Appendix F

Part 5

Figure 1. Hatchability, Aroclor 1248 Dose to Chicken Hens

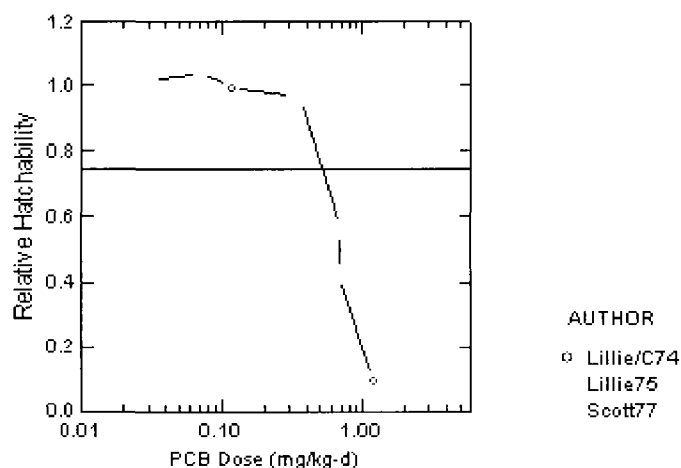
The methods used to derive some of the TRVs for both mink and birds are novel and their utility and accuracy have not been established. In particular, CBS has a number of concerns about the TRVs and the methods that were applied in deriving them that were presented in the document entitled “Toxicity Reference Values (TRVs) for Mammals and Birds Based on Selected Aroclors”, from USEPA Region V, dated March 6, 2003 (which is included as a part of USEPA 2005, Focused Ecological Risk Assessment, PCBs and Mammalian and Avian Piscivores in Conard's Branch and Richland Creek, August 10). For example, the combination of data from various studies and then the extrapolation of NOAELs and LOAELs from the combined data sets have several obvious limitations, including the comparability of methods between studies. To our knowledge, these approaches have not been externally peer reviewed and are in contrast to the typical EPA method of deriving TRVs from relevant single high value studies.

Eight sets of TRVs are used in the FERA, the comments pertain to 2 of these 8 sets. The TRVs in question are based on meta-analysis of multiple toxicity studies, a procedure used to derive mink dietary no effect (500 μg total PCB/kg diet) and low effect (600 $\mu\text{g/kg}$) TRVs, and kingbird ingestion dose no effect (400 μg total PCB/kg_{BW-d}) and low effect (500 $\mu\text{g/kg}_{\text{BW-d}}$) TRVs. The remaining 6 sets of TRVs in the FERA are derived through other approaches, including a second set of kingbird PCB ingestion TRVs used to bracket uncertainty over kingbird sensitivity to PCBs.

CBS incorrectly states that the TRVs are extrapolated, but the meta-analytical method in the FERA is restricted solely to interpolation within the combined data sets, and extrapolation beyond the bounds of the empirical data is not allowed.

Incompatibilities between studies because of differences in study design or other factors are potentially important limitations of meta-analysis and, therefore, are evaluated as part of the meta-analysis performed for the FERA. Significant incompatibilities between studies are revealed by inconsistencies in the exposure-response plots of the combined data sets. There are no inconsistencies among the 3 studies performed by two sets of investigators combined in the meta-analysis of PCB effects on hatchability, to the contrary, the results of the various studies are remarkably consistent with each other (Figure 1). The mink PCB TRVs are based on 4 studies performed by three sets of investigators (two separate experiments reported in Aulerich and Ringer 1977 are included in Figure 2). The results are internally consistent except for an inconsistency between studies at 1 mg/kg PCB dietary concentration (Figure 2). For the FERA, the two data points are averaged before calculating the TRVs, but, if the data point showing greater toxicity at 1 mg/kg PCB is excluded (Aulerich and Ringer 1977), and the TRVs are calculated with only the Wren, et al. (1987) data point to represent the response at 1 mg/kg PCB (showing less toxicity), the TRVs increase by no more than 15 %. Therefore, the difference between studies at this dietary concentration has only a minor influence on the calculated TRVs. Mink reproduction is consistently suppressed in treatments at or above 2 mg/kg dietary concentrations.

Figure 4. Live Kits per Mated Female Mink Exposed to Field-contaminated Fish for Single and Multiple Breeding Seasons or Generations (Restum, et al. 1998)

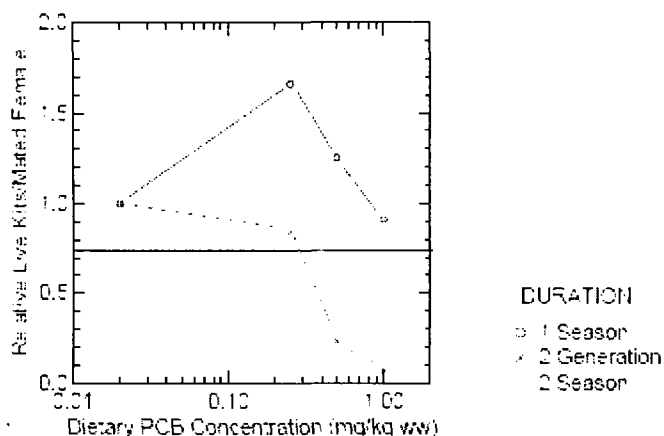
The TRVs for mink have been adjusted to account for two breeding seasons. It is not clear that this is a generally accepted or scientifically valid procedure. In their TRV memo, USEPA evaluated the Brunstrom et al., (2001) study and concluded that “the low effect TRV for exposure over 2 breeding seasons (1.3 ppm PCB) is 42% of the corresponding TRV for 1 season exposure (3.1 ppm), and the 2-season no effect TRV (1.1 ppm) is 47% of the 1-season value (2.4 ppm).” These TRVs are clearly artifacts of the interpolation method used by USEPA since only two doses were evaluated by Brunstrom et al., (2001) and yet USEPA derived four different TRVs from this study. Furthermore, USEPA’s TRVs are based on a narrow definition that considers only a single endpoint rather than deriving a TRV based on the most sensitive, ecologically relevant endpoint(s), as is commonly done with setting a TRV. Clearly, the results of Brunstrom et al., (2001) demonstrate the toxicity of the European Clophen technical mixture. If one focuses on reduced birth weight of kits as an endpoint, then it is clear from this study that the LOAEL TRV (0.3 mg Clophen A50/mink/d or 2 mg/kg in diet) is the same for both the 6-month and 18-month exposures (compare Tables 3 and 5 in Brunstrom *et al.*, 2001). However, the more sensitive endpoints from this study were the numbers of 2-week old kits per mated female and weights of kits at 2 and 5 weeks of age. Using these more sensitive endpoints, the LOAEL is 0.1 mg Clophen A50/mink/d (or 0.67 mg/kg in feed) at the 18-month exposure. However, since the authors did not present data on these endpoints for the 6-month exposure, there is no way to directly compare TRVs for 6 and 18-month exposures for these endpoints. Thus, this study does not support the derivation of a 1-season to 2-season uncertainty factor. Similarly, USEPA’s

analysis of the Restum et al., (1998) study does not support a 1-season to 2-season uncertainty factor. Again, the TRVs derived from this study by USEPA are artifacts of the interpolation method used by USEPA and the narrow definition of a TRV that utilized a single endpoint rather than deriving a TRV based on the most sensitive, ecologically relevant endpoints. As before, the lowest dose tested for both seasons determined a LOAEL and therefore, the uncertainty associated with estimating a NOAEL from this study would be relative great. For example, based on the most sensitive, ecologically relevant endpoint from this study, reduced body weight of 6-week old male kits, it is clear that the LOAEL TRV (0.25 mg PCBs/kg in diet) is the same for both the 6-month and 18-month exposures (compare Tables 8 and 9 of Restum et al., 1998). Thus, this study and the other study cited by USEPA (Brunstrom et al., 2001) do not support the derivation of a 1-season to 2-season uncertainty factor. The most recent high quality studies (for example the Housatonic River fish feeding studies detailed in Bursian et al 2003) have not involved multiple breeding seasons. Similarly the USFWS is planning a similar mink feeding study with Hudson River Fish and this is also proposed as a single season study (Hudson River Natural Resource Trustees 2006). This is an indication that multiple breeding seasons are not judged to be a significant factor in TRV development for mink by much of the scientific community including EPA or FWS at other high profile PCB sites. If this factor was omitted, the resulting Hazard Quotients would drop by about a factor of 2.

CBS's comments on the Restum, et al. (1998) study conflates the methodology for statistically deriving TRVs with the methodology for interpolation of TRVs from dose-response curves. Statistically significant differences are not prerequisites for including treatments in dose-response plots – to the contrary, *all* treatment results should be included in dose-response plots to understand how toxicity changes with exposure. Figure 4 illustrates the dramatic effect of exposure duration on live kits per mated female mink in the Restum, et al. (1998) study.

The increasingly adverse effects of PCB exposure over 2 breeding seasons or 2 generations compared to exposure over a single breeding season in the Restum, et al. (1998) study are not “artifacts of the interpolation method”, but are supported by the statistical analyses presented in the study. The LOAEC for kit survivability with only a single breeding season exposure is 1 ppm PCB, whether assessed at birth, 3 weeks, or 6 weeks after birth. In contrast, with continuous exposure over 2 breeding seasons, the LOAEC for kit survivability is 0.5 ppm at 3 and 6 weeks after birth. Similarly, with continuous exposure over 2 generations of mink, the LOAEC for kit survivability is 0.5 ppm at birth, 3 weeks, or 6 weeks after birth (Table 7 in Restum, et al. 1998). In other words, there is a 2-fold decrease in the LOAEC for kit survivability when PCB exposure is increased from a single breeding season to 2 breeding seasons or 2 generations.

Figure 5. Arithmetic Mean Lipid Content and Geometric Mean Lipid-normalized PCB Concentration in Longear Sunfish Collected in November from Sample Station 4 (Strainridge Road), Clear Creek, Lemon Lane Landfill Site, Bloomington, IN.

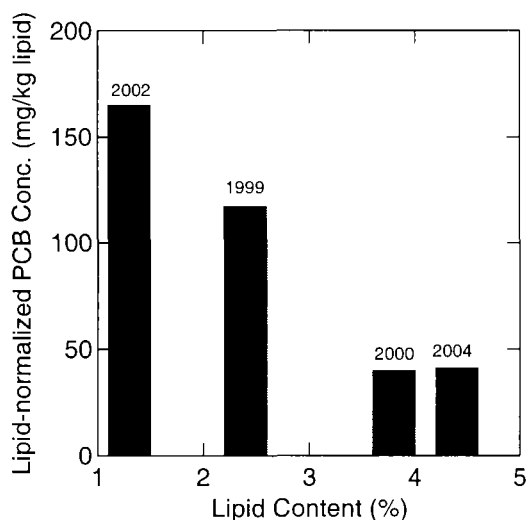
Refer to Figure 1. This Figure shows the calculated hazard quotients for mink at each of the 4 stations for all sampling events since 1996 using EPA's methods (EPA NOEL TRV and CTE PCB levels). There were two sets of fish data taken prior to construction of the ICS treatment plant in 2000. The data clearly shows that while the 1996 hazard quotients are higher than post 2000 levels, the 1999 hazard quotients for fish at stations 2, 3 and 4 are essentially the same as those after completion of the treatment plant. This would indicate that the PCBs in the fish of the main stem of Clear Creek have not changed substantially from the 1999 levels. Since the ICS treatment plant, in its current configuration captures the vast majority of PCBs issuing from ICS this indicates that most of the PCBs in the fish of the main stem of Clear Creek are not driven by PCBs which issue from ICS or currently bypass treatment. Put another way, the source control measures at Lemon Lane Landfill and the treatment of water at ICS have had no significant impact on risk levels in the main stem of Clear Creek when compared to 1999 levels.

Additionally, note that the calculated hazard quotients do not change much as you get farther from the assumed source at ICS. In fact the calculated hazard quotients for station 4 (20 miles downstream from ICS) are higher than for stations 2 and 3 (station 2 is only a few miles from ICS) and essentially equal to station 1 (which is within 2 miles from the ICS). EPA has noted this apparent discrepancy and explained it by looking at the difference between sizes and types of fish sampled at the various locations (USEPA 2006). However, the effective dilution between station 1 and station 4 is huge. For example, see Table 2. This table shows the flow estimates at various points along the creek. The flow was estimated at about 100 gpm near station 1. While upstream of station 4 (at Ketcham Rd on the table) the flow was almost 9000 gpm. Since there are other significant tributaries which enter Clear Creek between Ketcham Rd and Strainridge Rd (station 4), the flow at station 4 surely is greater than 9000 gpm. This implies an effective dilution ratio of more than 90 to 1 (and likely closer to 100 to 1) between station 1 and 4. This implies that PCBs which currently bypass treatment at ICS would be substantially diluted prior to reaching station 4 and only a minor source to fish at station 4. This dilution effect is seen in other stream systems around Bloomington. For example, PCB levels in the main stem of Richland Creek fish drop off dramatically as you get more than a few miles from Neal's Landfill (the only known source of PCBs to Richland Creek) due to dilution even though the fish at further downstream locations are in some cases larger than those sampled much closer to the site (see USEPA 2001) and the same effect is seen in Stout's Creek near Bennett's Dump. In most creek systems, PCB levels in fish will drop as you get farther downstream from a source due to dilution effects. The fact that this does not happen in Clear Creek indicates that the PCBs which bypass treatment at ICS are not a controlling source to fish more than a few miles downstream.

The analysis and figure presented in CBS's comments are not appropriate approaches for assessing temporal trends in PCB exposures to mink feeding on Clear Creek fish because of inconsistencies in the species composition of the fish samples used to model mink dietary exposures between sampling events. For example, the mink risk estimates at Station 4 are based on a mix of green sunfish and hog suckers in 1996; longear sunfish, stonerollers, rock bass, bluegill, and hog suckers in 1999; longear sunfish, hog suckers, and redhorse in 2000; longear sunfish and rock bass in 2002; and longear sunfish and redhorse in 2004. Different species of fish accumulate PCBs differently depending on species-specific diet (trophic status), metabolism (elimination of PCBs), foraging behavior (amount of sediment contact), movement (duration of exposure where collected), and lipid content (higher lipid content is normally associated with higher whole-body PCB concentration). The temporal trends in modeled mink dietary PCB exposure are confounded by the shifts in fish species sampled between years, by changes in fish lipid contents among species and between sample years, and by apparent movement of small numbers of fish between sample locations shortly before collection (data outliers).

All of the species-location examples with 1996 data show decreased lipid-normalized PCB accumulation in fish in 2004 compared to 1996 (creek chub in Stations 1 or 2, and green sunfish in Stations 2 or 3). Most of the examples with 1999 data also show decreased lipid-normalized PCB accumulation in fish in 2004 compared to 1999 (creek chub in Station 3, and longear sunfish in Station 4). An exception is creek chub in Station 2, which show higher lipid-normalized PCB accumulation in 2004 compared to 1999 (but much lower accumulation compared to 1996). Overall, these data do not support CBS's claim that the water treatment plant has had no effect on the main stem of Clear Creek.

An unusual pattern in the data is an inverse relation between mean lipid content and lipid-normalized PCB concentration in the same species at a single location but collected in different years. This pattern is most apparent in the lower reaches of Clear Creek, for example, longear sunfish in Station 4 (Figure 5) and green sunfish or creek chub in Station 3 (Table 1). A possible explanation for this pattern is redistribution of accumulated PCBs to dwindling lipid reserves in stressed fish, as has been reported in fasting animals (Lydersen, et al. 2002; Debier, et al. 2006; Fuglei, et al. 2006). Sampling for the Neal's Landfill site shows markedly decreased fish lipid contents in November compared to May or August. If a similar seasonal pattern holds for Clear Creek fish, in years in which fish use large portions of their lipid reserves late in the season, the November lipid-normalized PCB concentrations would be elevated compared to less stressful years in which the fish maintain higher lipid reserves and therefore do not internally redistribute previously absorbed PCBs.

Regardless of the explanation, the inverse lipid content – lipid-normalized PCB concentration relationship further complicates evaluation of temporal trends in fish PCBs in Clear Creek. One way to minimize this effect is to compare lipid-normalized PCB concentrations when the mean lipid contents are similar between sample dates. Two of three comparisons indicate decreased PCB exposure. Decreases in lipid-normalized PCB concentrations at similar lipid contents occur in Station 2 creek chub (1996 – 2004) and
